**KETCHUM FIRE STATION DESIGN REVIEW  
STAFF REPORT UPDATE  
KETCHUM PLANNING AND ZONING COMMISSION  
SPECIAL MEETING OF FEBRUARY 24, 2020**

**PROJECT:** Ketchum Fire Station

**FILE NUMBER:** P20-013

**APPLICATION:** Design Review

Figure 3. Conceptual layout of warning sign locations that warn drivers and pedestrians/bicyclists.

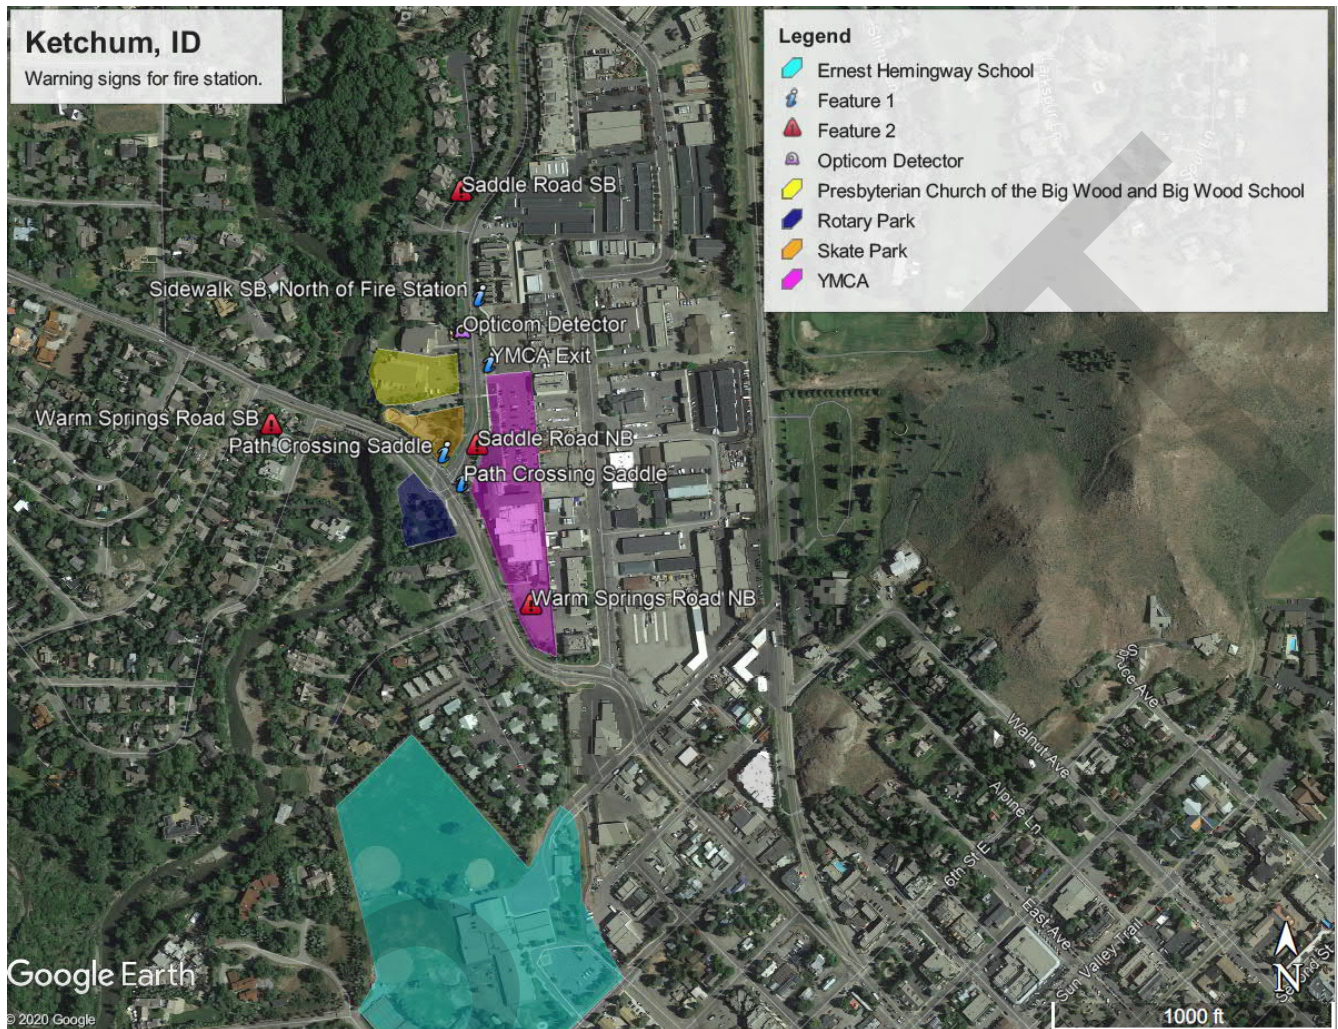
- A system can be installed that includes Fire Station Warning signs (W11-8) with flashing borders and/or flashing beacons to be activated when an emergency vehicle is leaving the fire station (see Figures 1 and 2). The signs would be deployed in strategic locations (such as trail crossings, locations near the Big Wood School or the YMCA, near transit stops, and on Saddle Road and Warm Springs Road, see Figure 3) that would alert pedestrians and bicyclists to the presence of an emergency vehicle.<sup>1</sup> Smaller signs are recommended for pedestrian/bicyclist applications.

**1 EAST ELEVATION**  
SCALE | 1/8" = 1'-0"

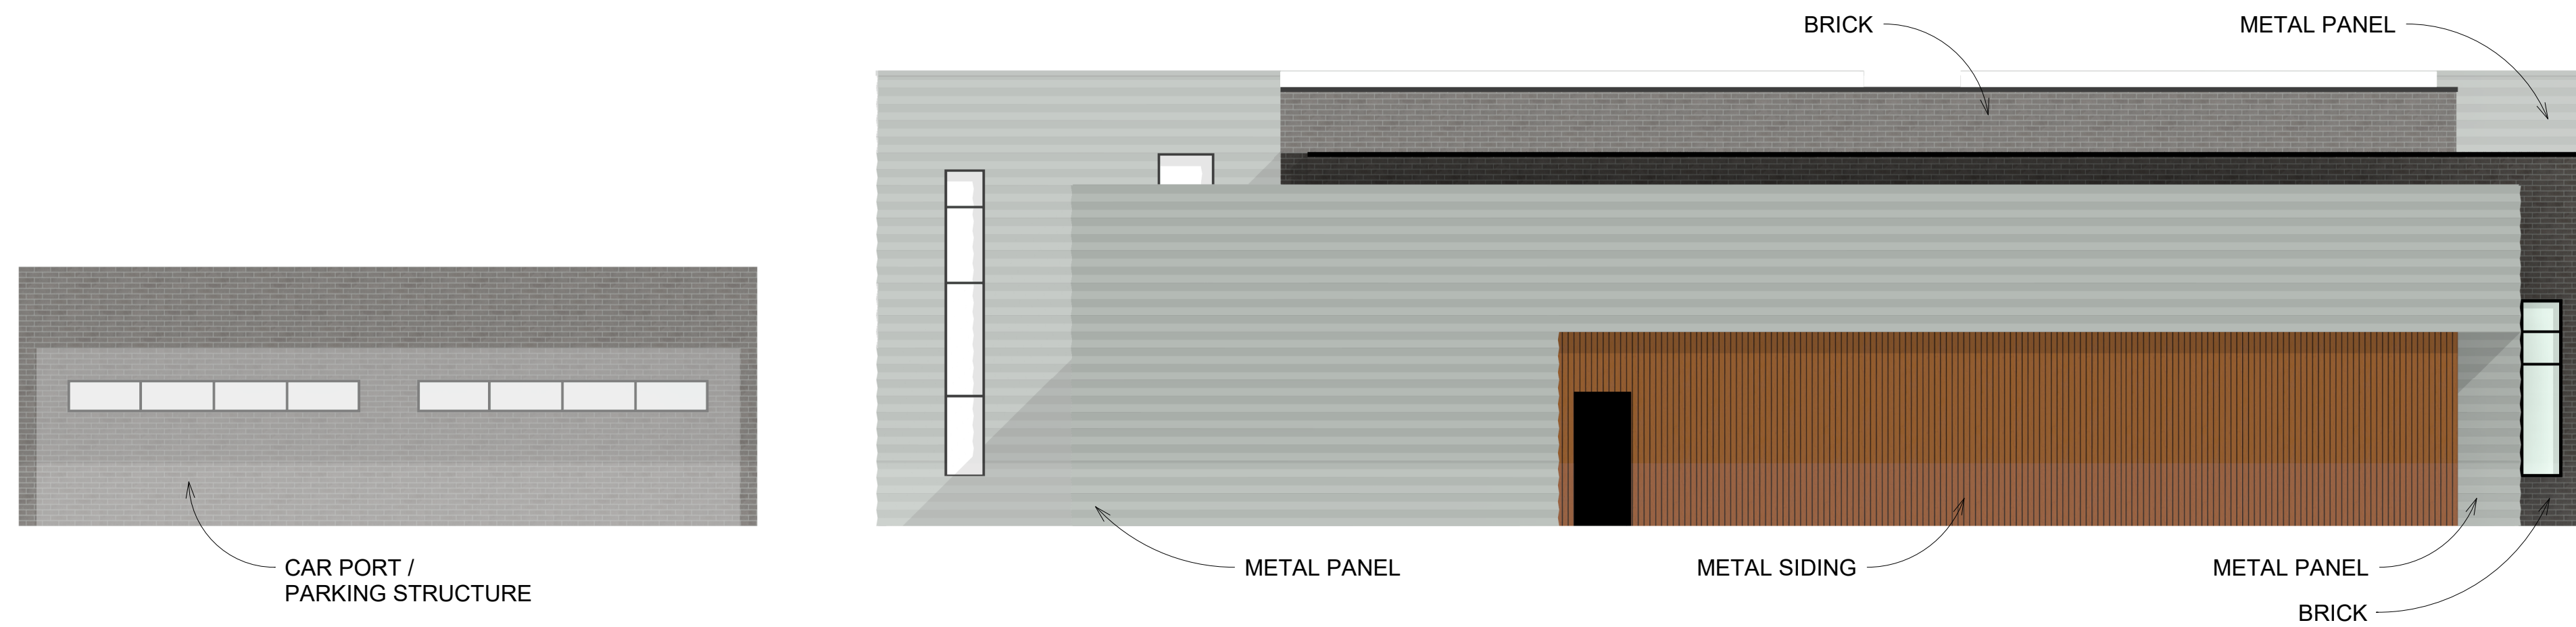
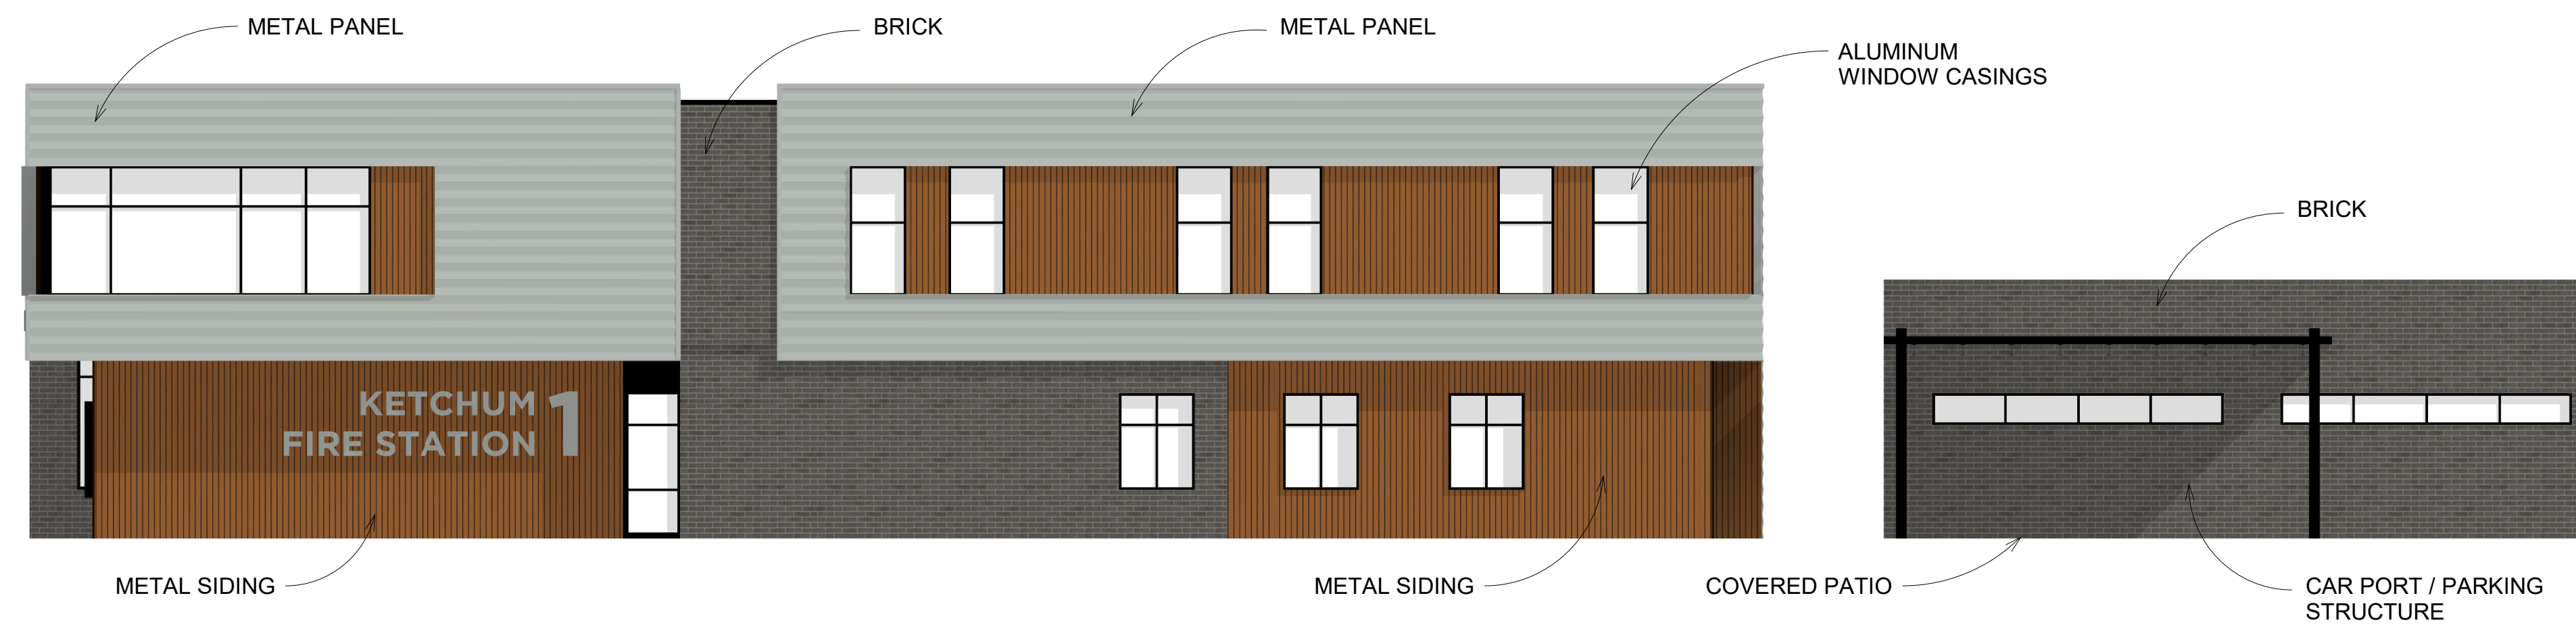
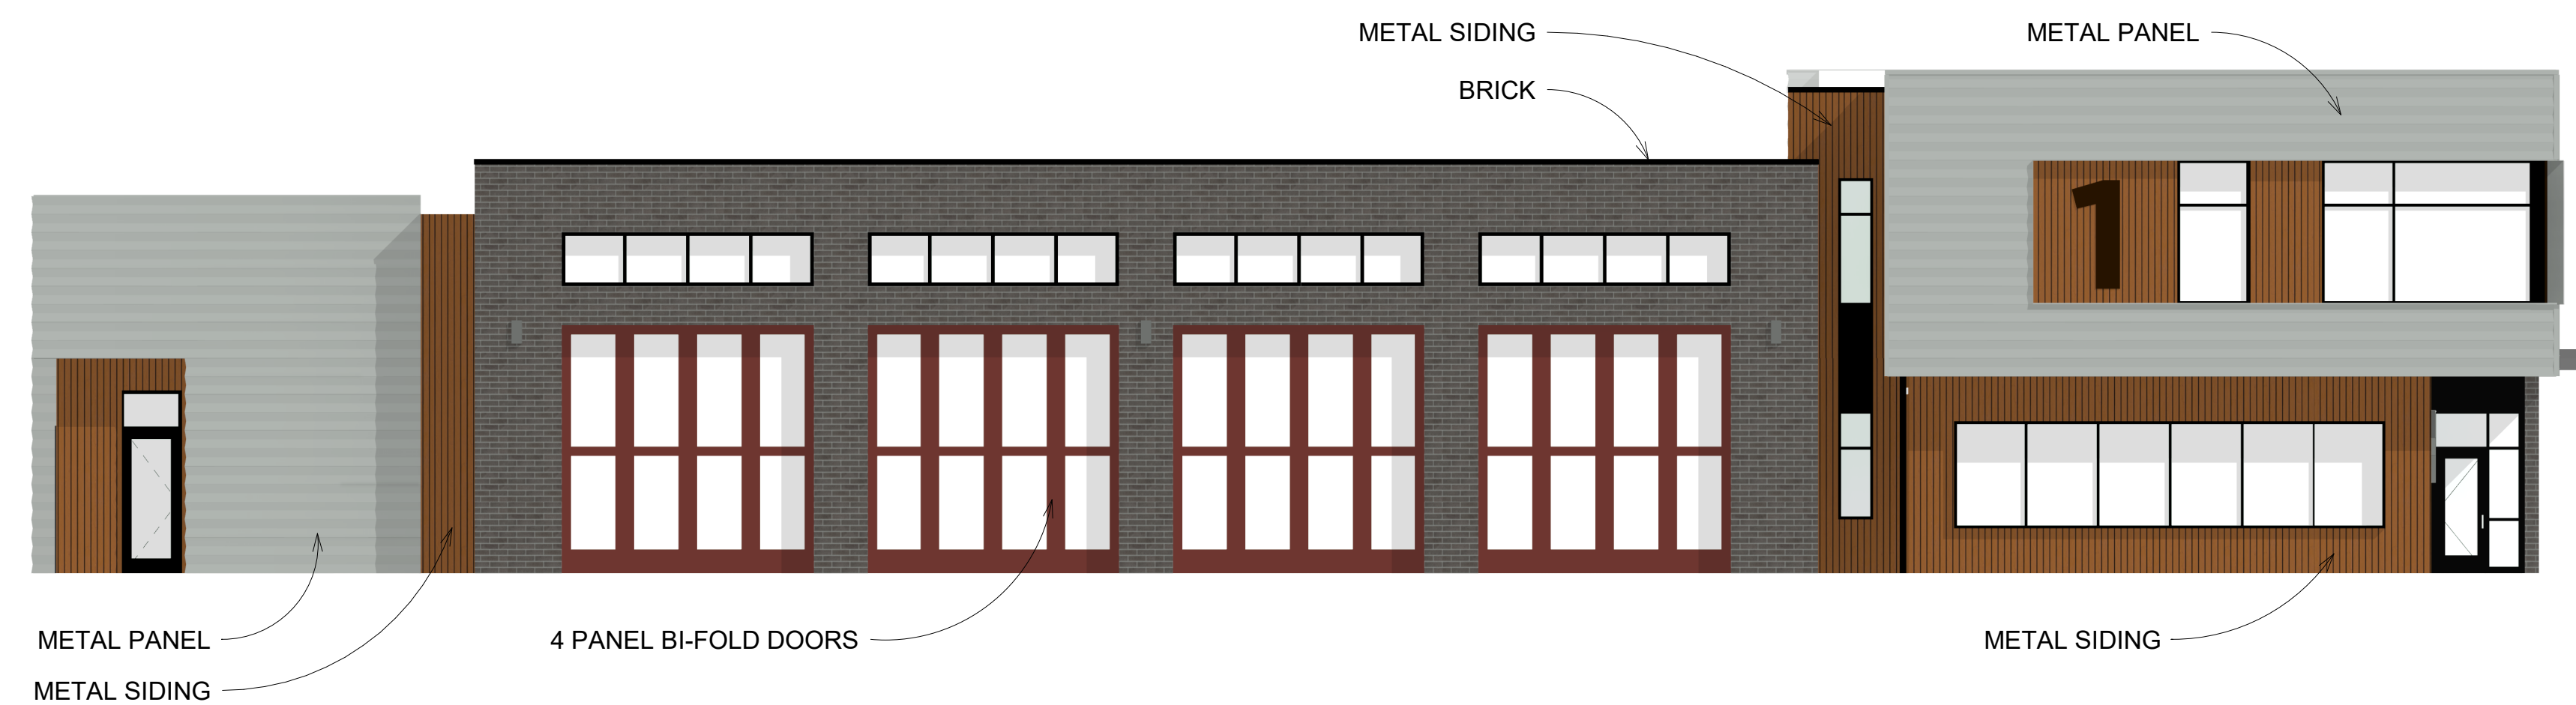
<i>Staff Comments</i>	<i>The exterior elevations (Sheet A3.00) show the proposed materials, colors, and signage. The façade design alternates gray horizontal metal panels with brown vertical metal siding. Projecting towards</i>
